November 15, 2018

**Re: Florida Power & Light Company
Sweetbay Solar Energy Facility Major Final Site Plan Application
Project Number: F109-002
Staff Report Reply Letter**

Itemized Responses to Staff Report

LAKE LANDSCAPE PLAN
SCALE: 1"=40'

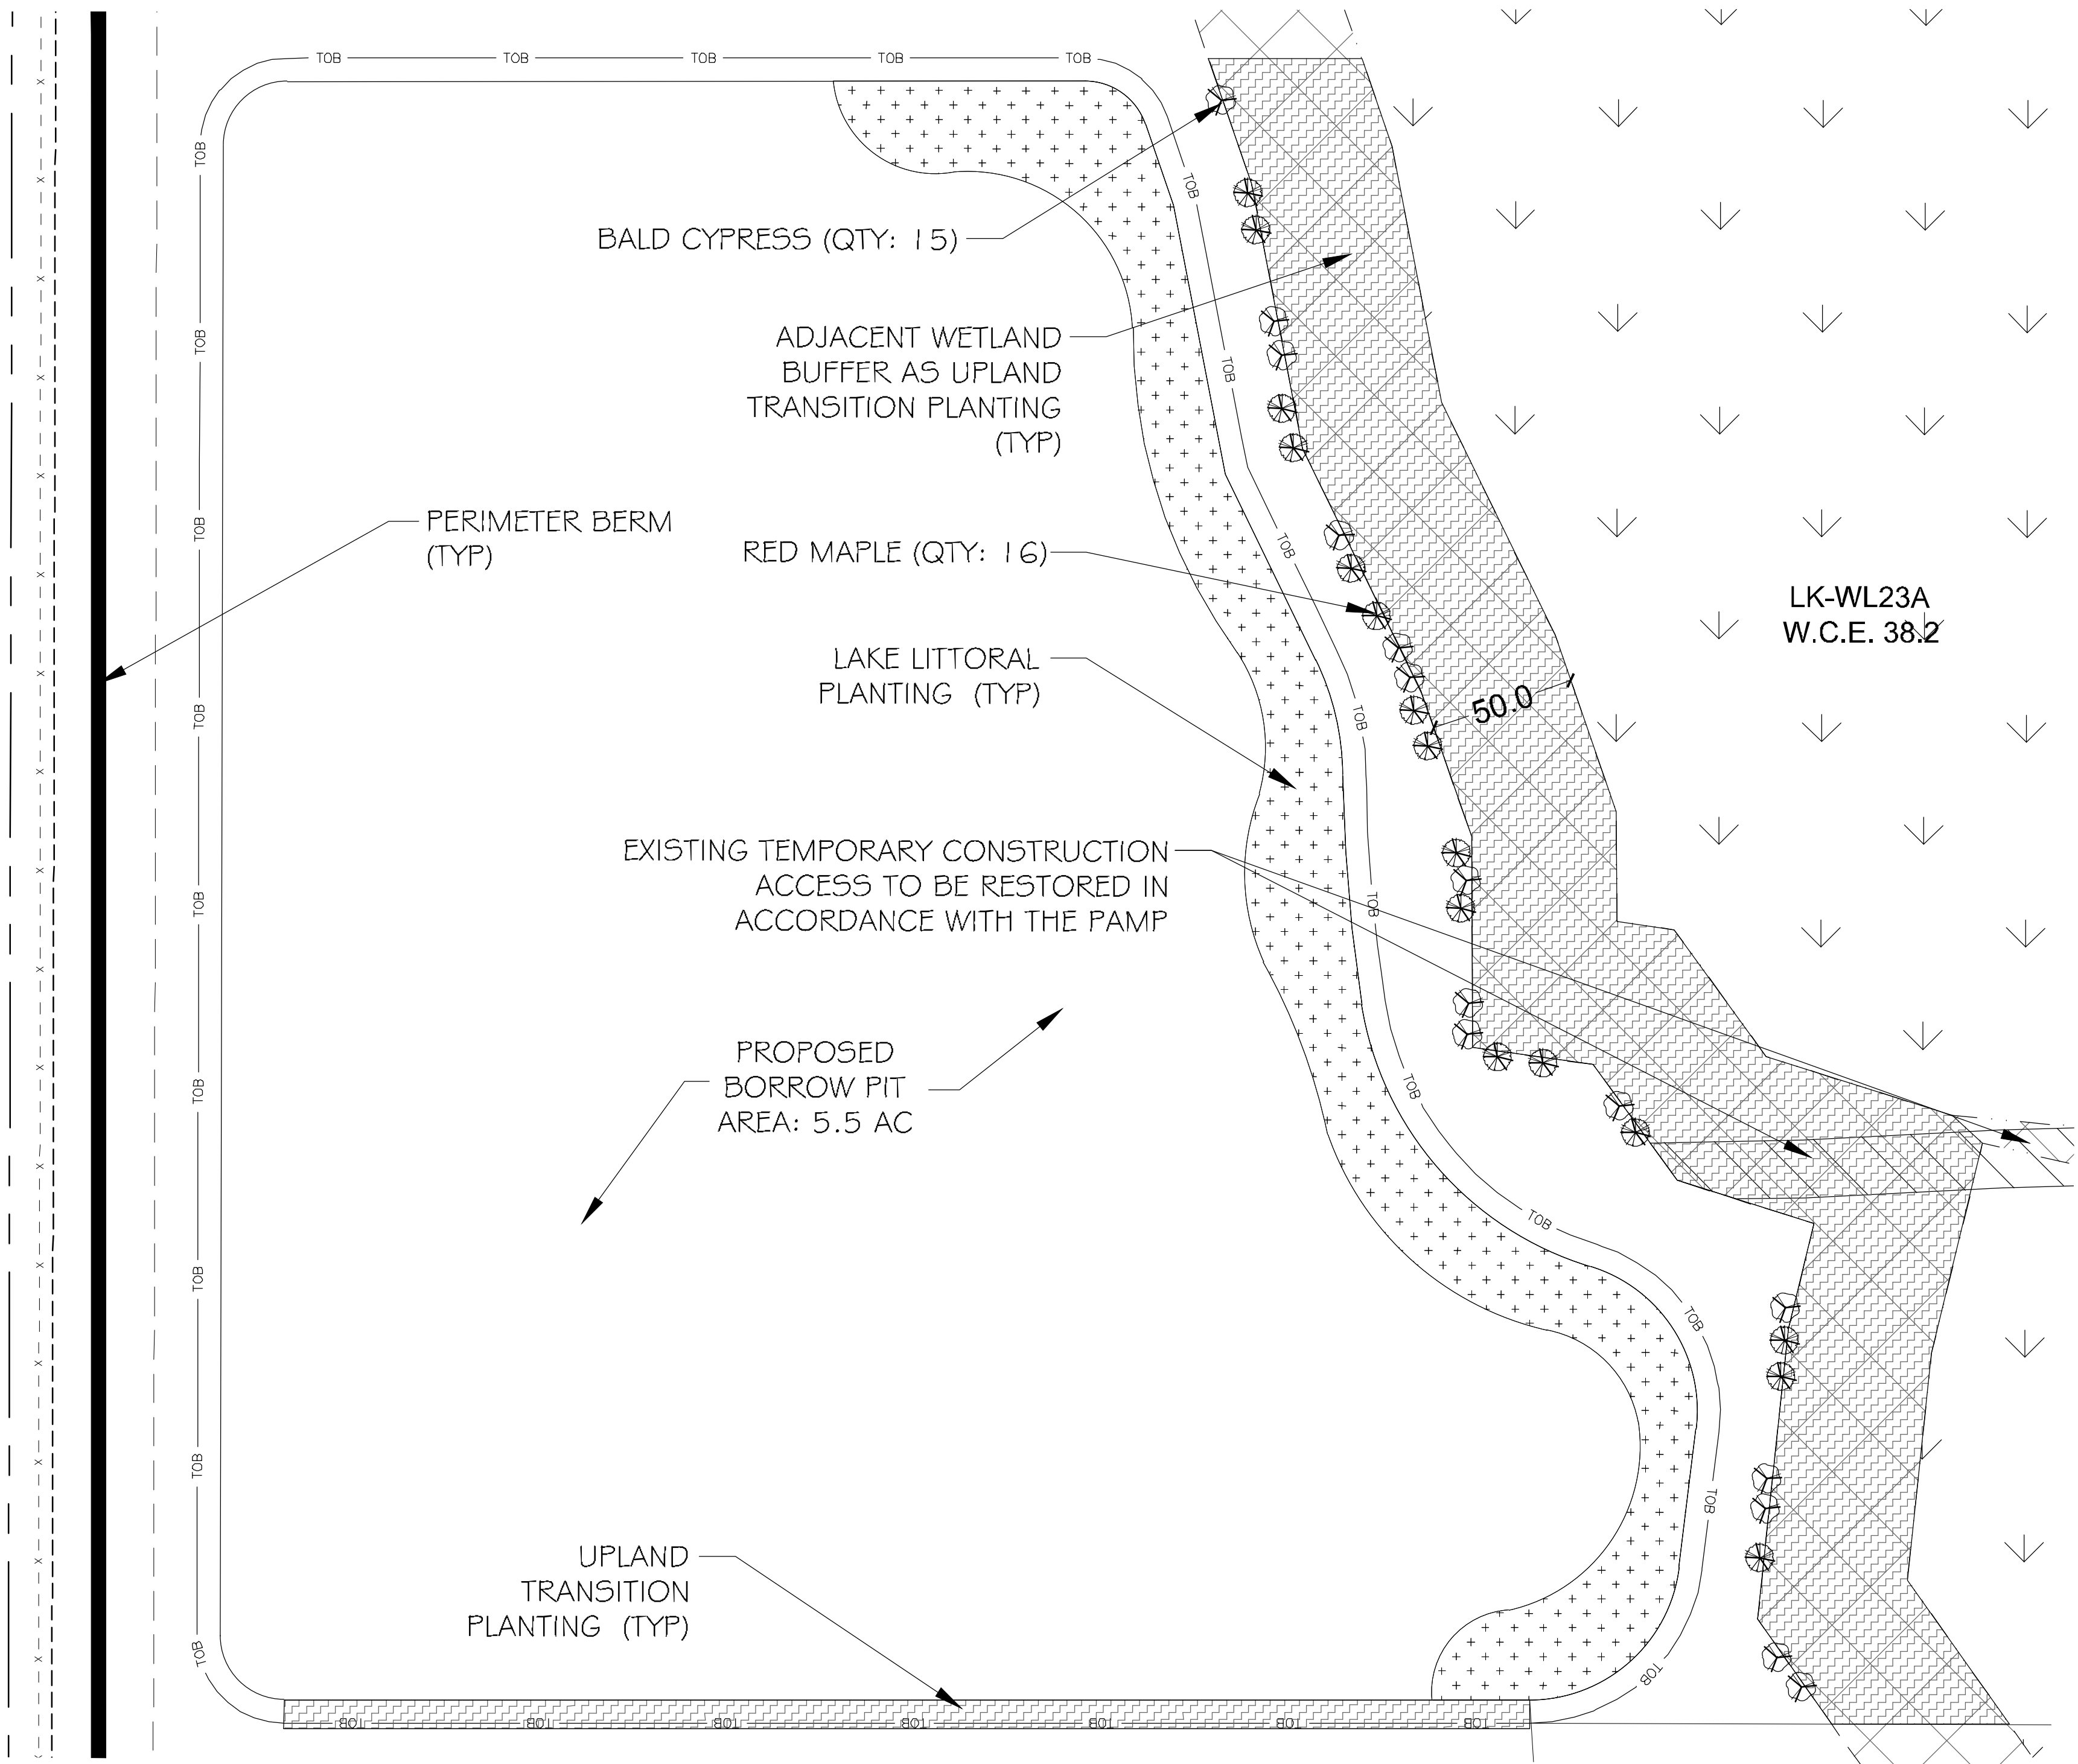
Remedy/Suggestion/Clarification: A Lake Management Plan has now been provided and densities of planted species within the littoral zones have been modified to meet requirements for herbaceous and tree planting requirements. However, no trees have been proposed to be established within the upland buffer that is to serve as portions of the upland transition zone.

Provide for installation of required trees within the portion of wetland buffer adjacent to the lake that is being utilized to meet the lake upland transitional buffer.

The lake littoral landscape plan enclosed has been revised to provide the required trees within and adjacent to the wetland buffer along the east side of the lake.

Figure 3 – Pre-Development Basin Map

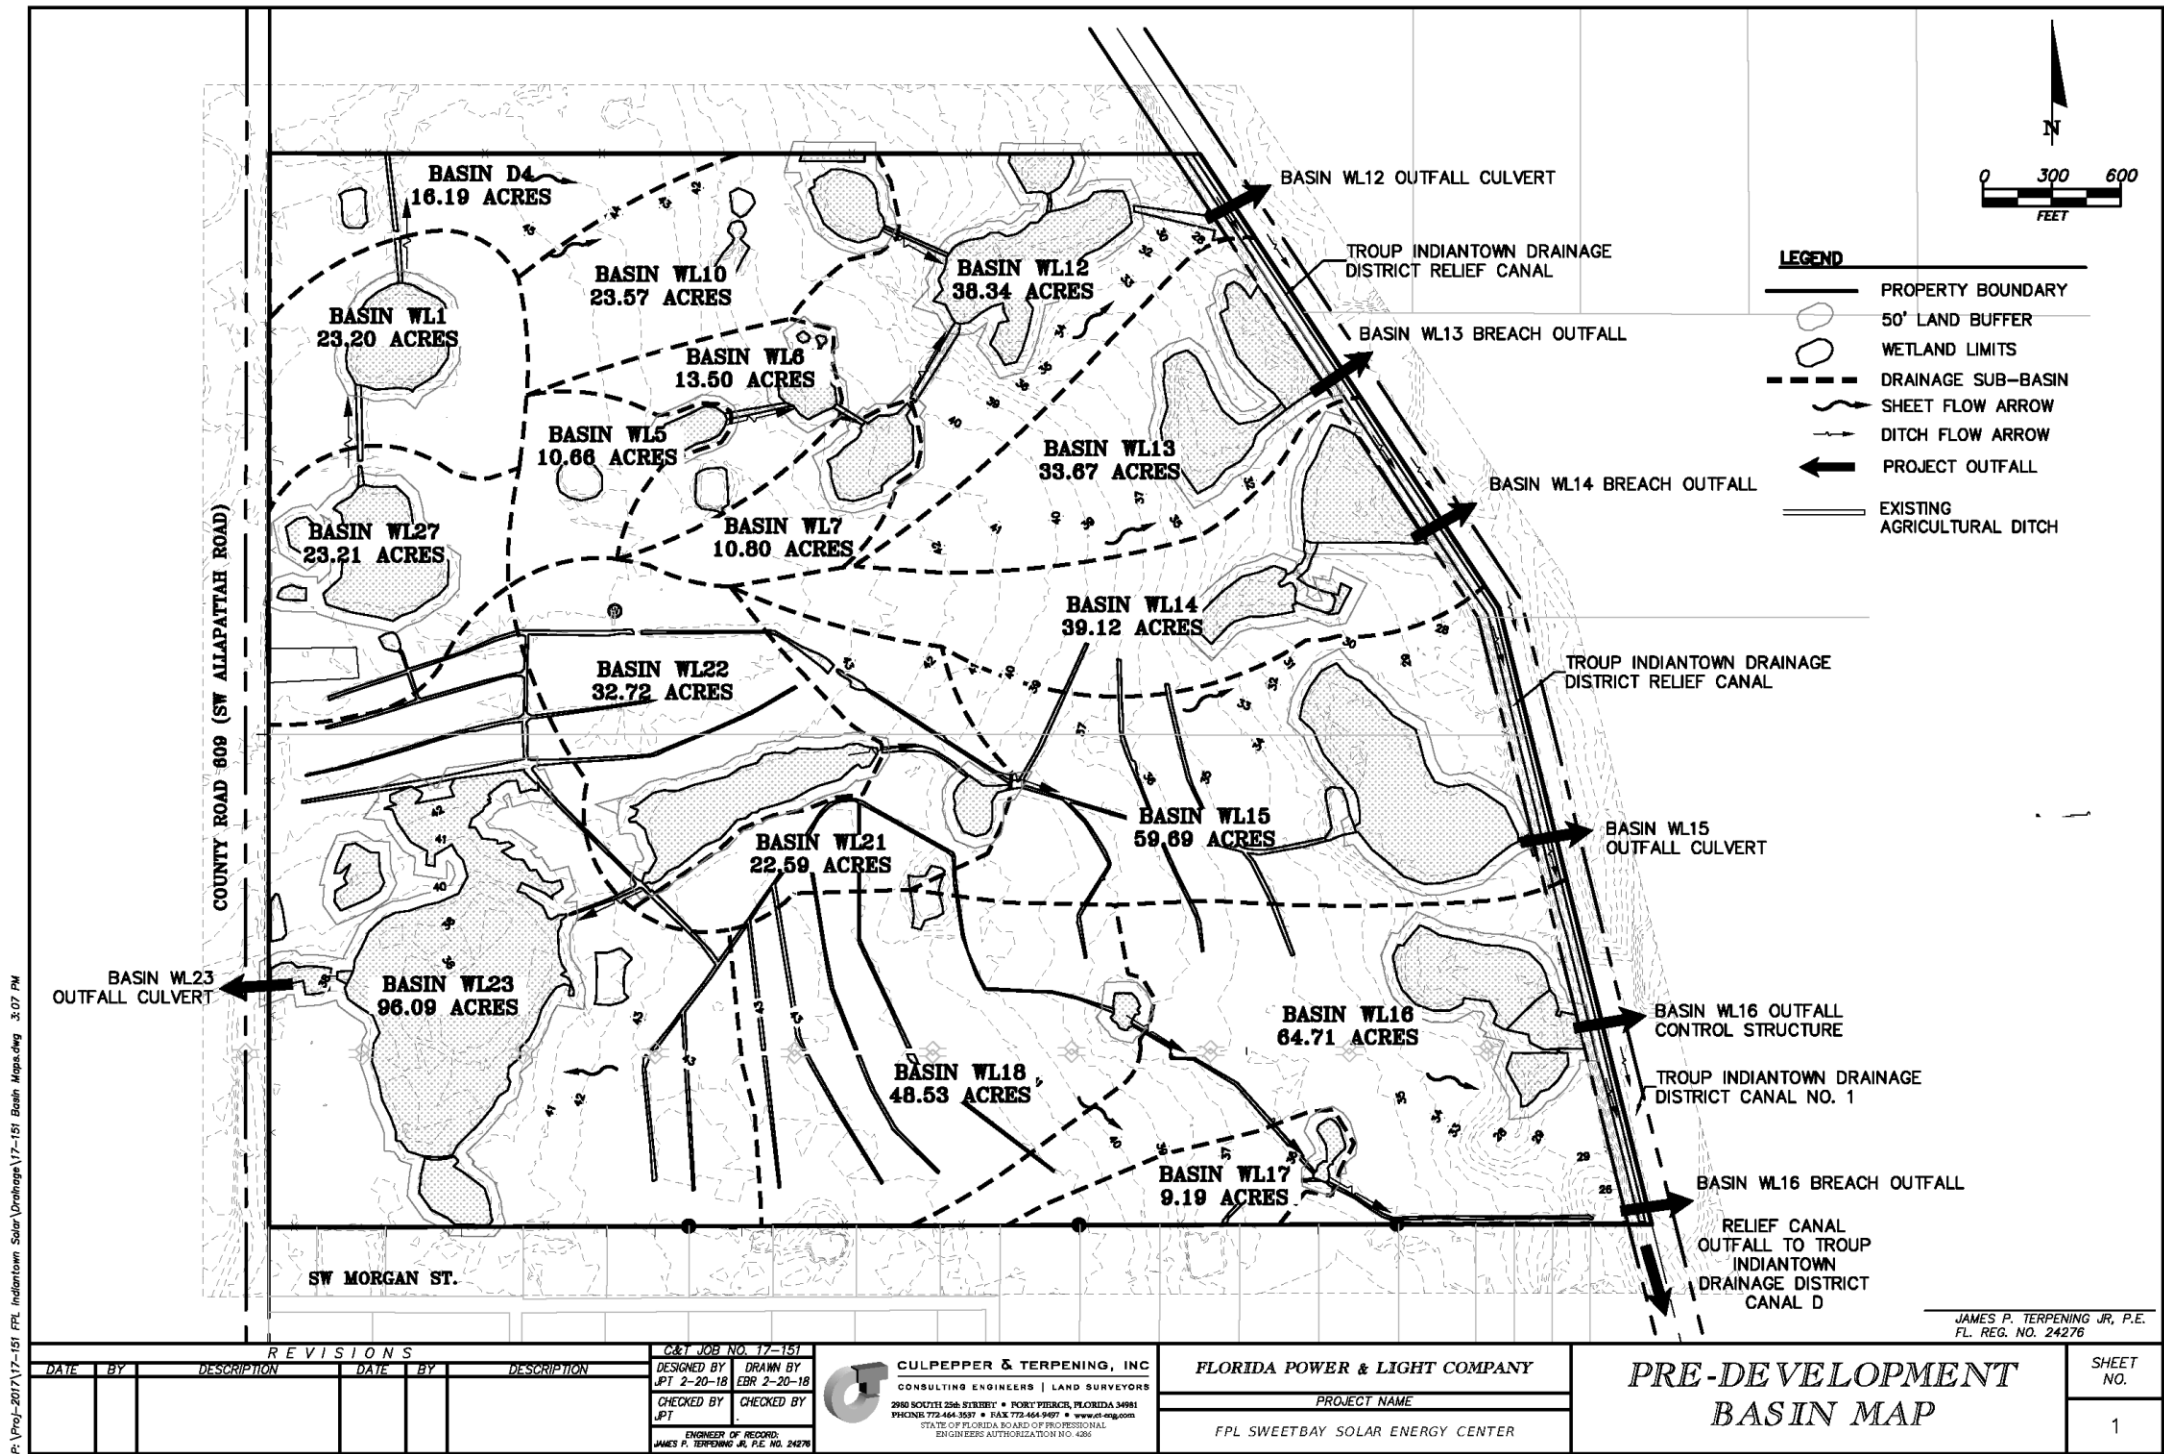
1. Pre-Development: As previously stated: Some stage/storage values are inconstant with the existing/proposed grades. For example: The pre-development depressional storage for Basin 10 is still listed as 6.65 acres in the stage storage table, however it appears to be only 0.81 acres when measured on the plans. Revisit all stage/storage tables to ensure they are consistent with existing/proposed grades.

The depressional open space storage refers primarily to the easterly basins and to the open space, which have a sloping topography. The depressional area within basin WL10 lies between elevations 34.9'-40' NAVD. This area of land was separated from the upland open space land in which the topography ranges from elevations 40'-45.5' NAVD. This delineation of open space land use was provided to depict the major variations of topography within the basin and to provide more accurate storage values.

Figure 4 – Post-Development Basin Map

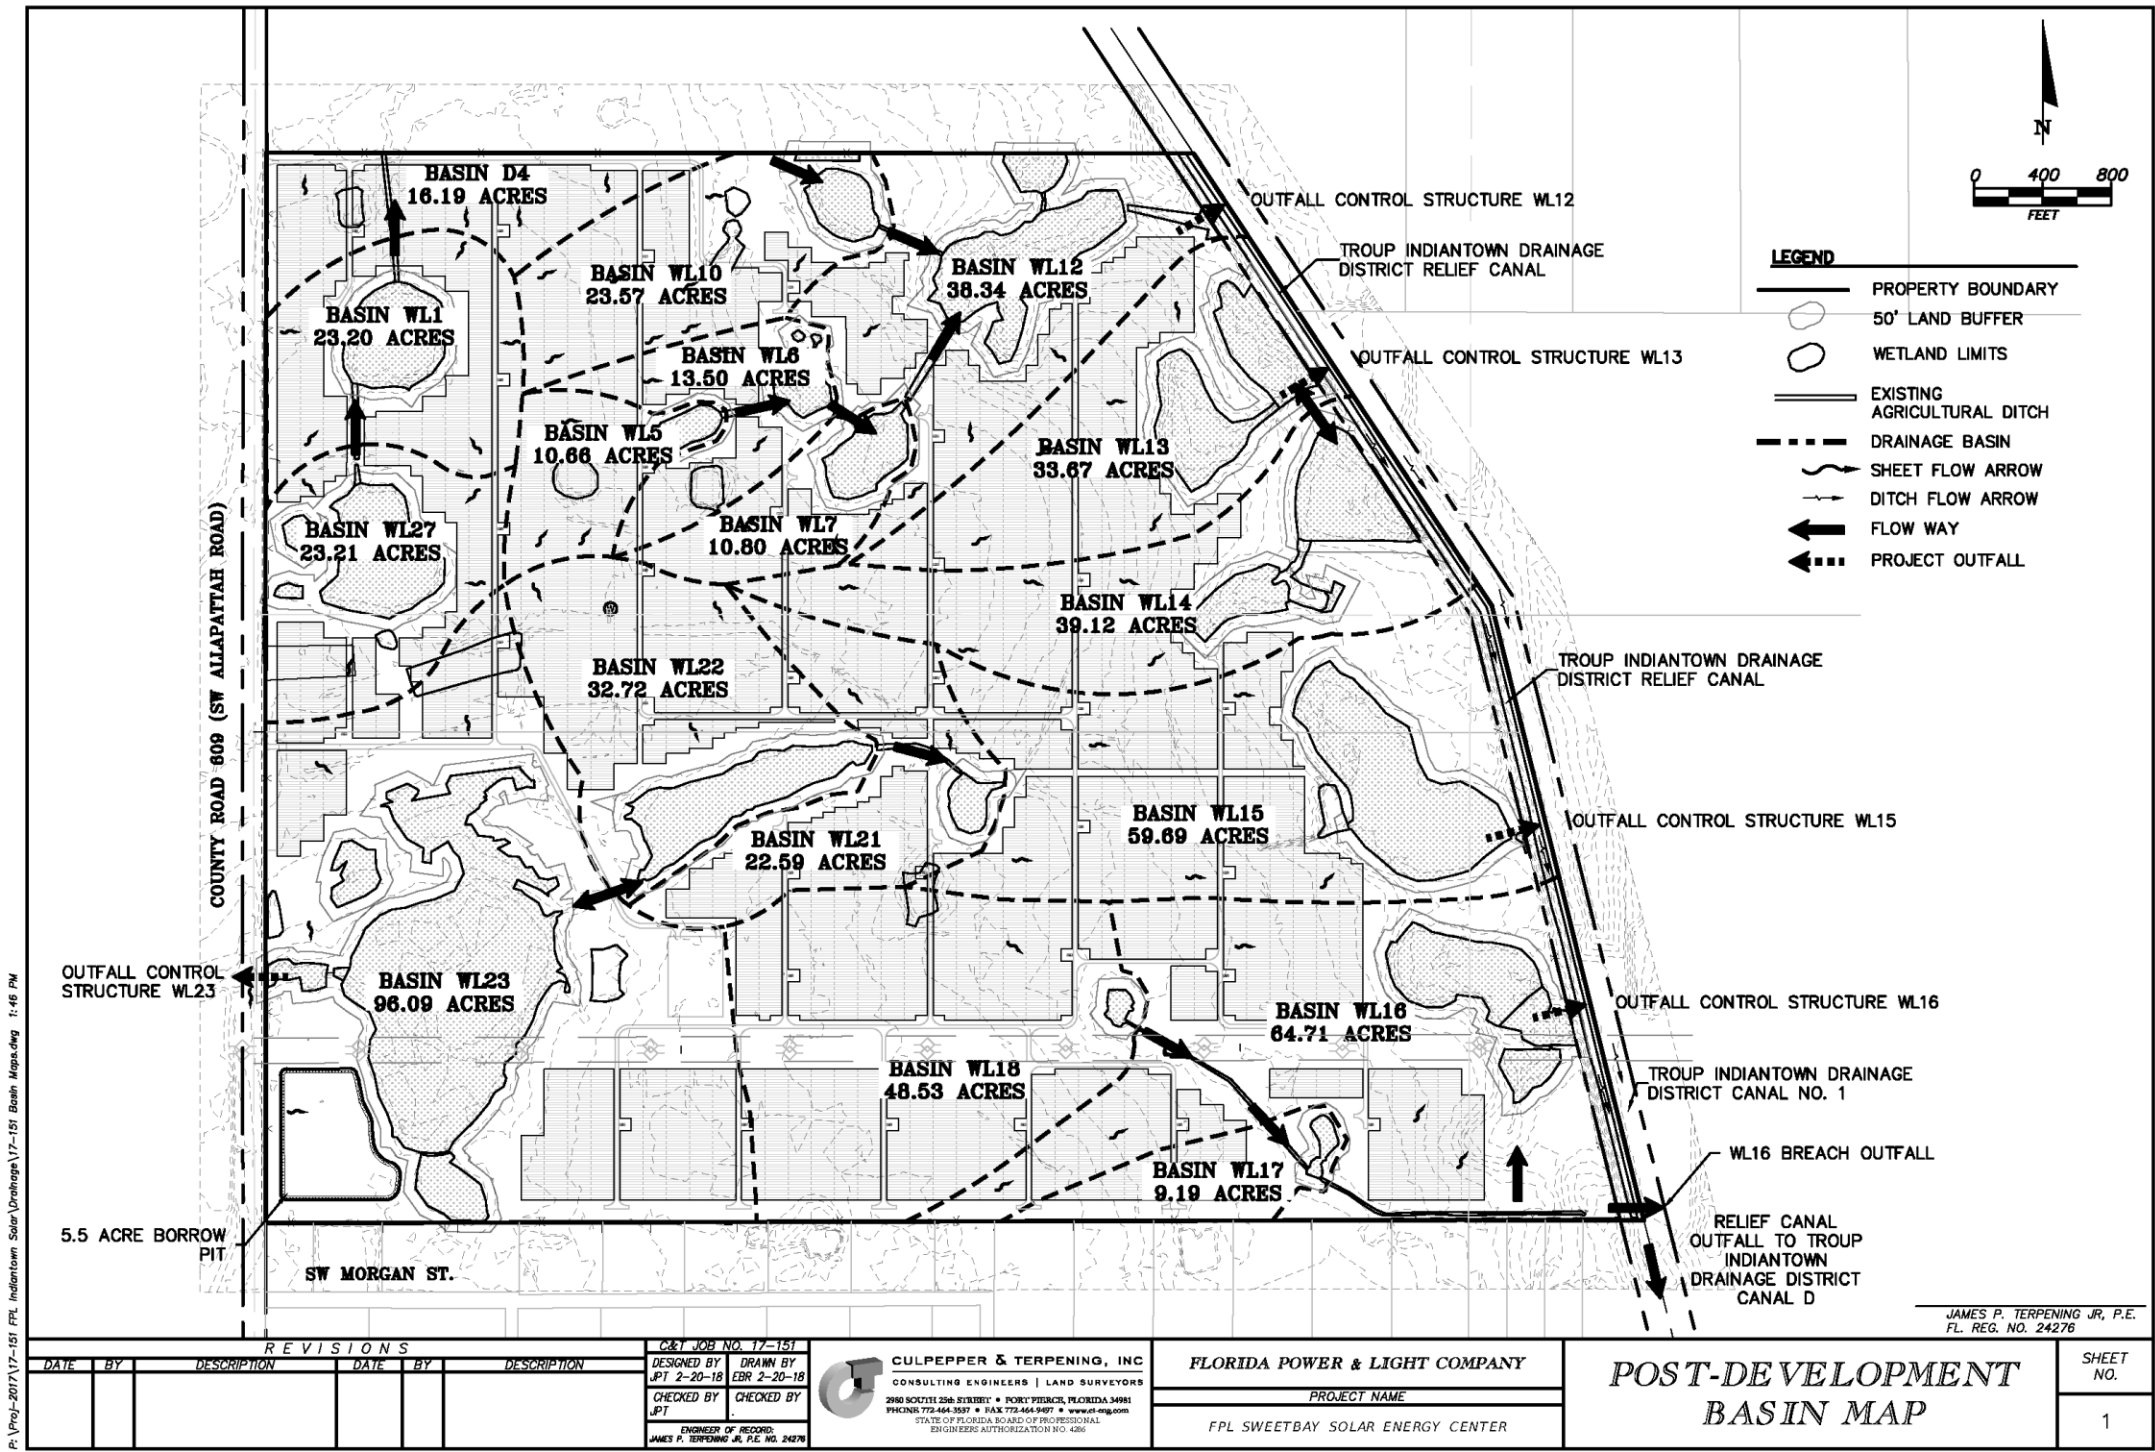
2. Post Development: As discussed during a phone conversation on 10/24/2018 with the Engineer of Record, James "Butch" Terpening, the proposed design will utilize a swale system for water quality treatment areas instead of the initial design of "vegetated natural buffers". Compliance with Post Development stormwater design requirements will be determined upon staff's review of the revised stormwater management report addressing the discussed changes.

Water quality swales have been added to the Constriction plans. A summary table, Table No. 5 "Martin County Water Quality," has been added to Sheet CE 20. In addition Section 4.1 "Water Quality" of the Stormwater Report has been revised to reflect the required treatment volumes.
